## SERVICE ASSEMBLY KIT FOR RM-483 MOWER LEVELING ROD BEARING

## TO OUR DISTRIBUTORS AND DEALERS

SUBJECT: RN-483 LEVELING ROD BEARING

Fig. 3

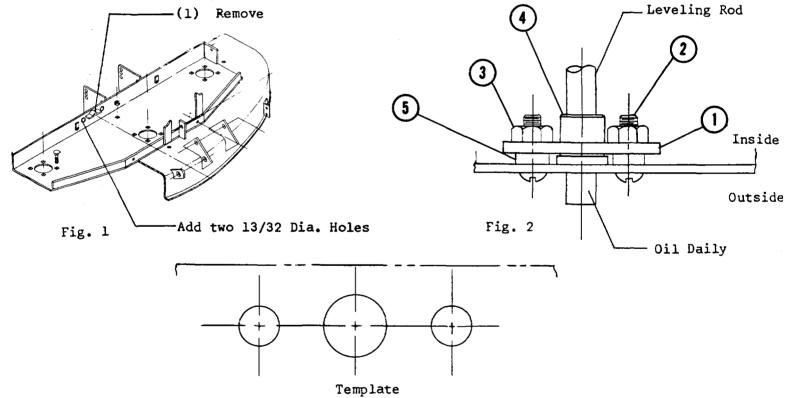
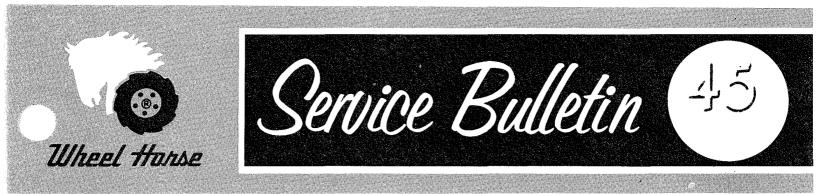
- I. Fig. 1 Remove welded wear plate (1) grind or file off excessive weld.
- II. Fig. 1 Use template (Fig. III) to center punch for two additional holes. Drill two 13/32 holes for 3/8" bolts.
- III. Fig. 2 Install service assembly as illustrated with bolts and spacer provided.

We have had some reports of excessive wear at the point where the leveling rod, Part Number 4399 goes through the channel assembly, Part Number 4265.

We have developed a KIT 6041 (copy attached) which provides an excellent bearing surface for this rod.
